GOVERNMENT OF THE DISTRICT OF COLUMBIA
DEPARTMENT OF TRANSPORTATION

MEMORANDUM

SUBJECT: ZC Case No. 16-26 – 4620-4624 Wisconsin Avenue, NW

Figure 2 – Streetscape Concept Plan (Source: CTR, Wells and Associates, Figure 4B, November 2016)

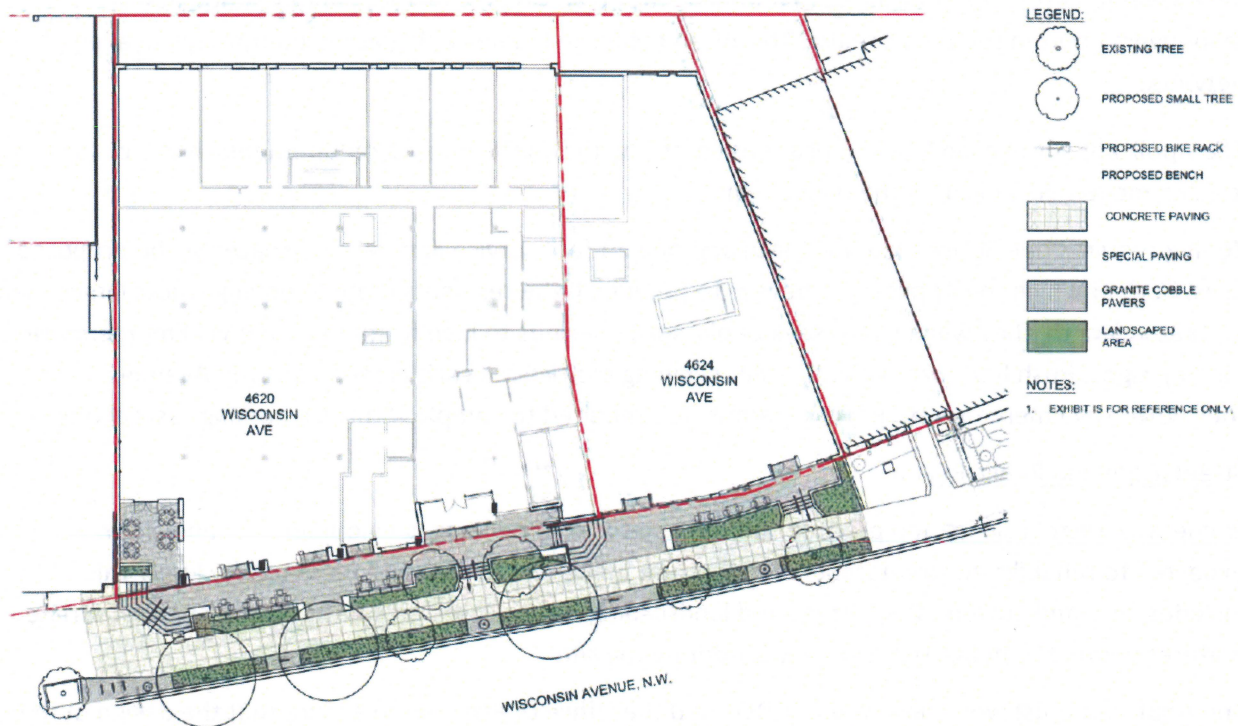
The Applicant shows on the proposed site plan within their CTR (see Figure 2) special paving in public space that exceeds what DDOT would permit. DDOT expects the Applicant to reduce special paving and increase landscaping, which will be coordinated during the public space permitting process. Finally, DDOT expects utility vaults to be accommodated on private property. All proposed curb cuts are subject to the public space permitting process.
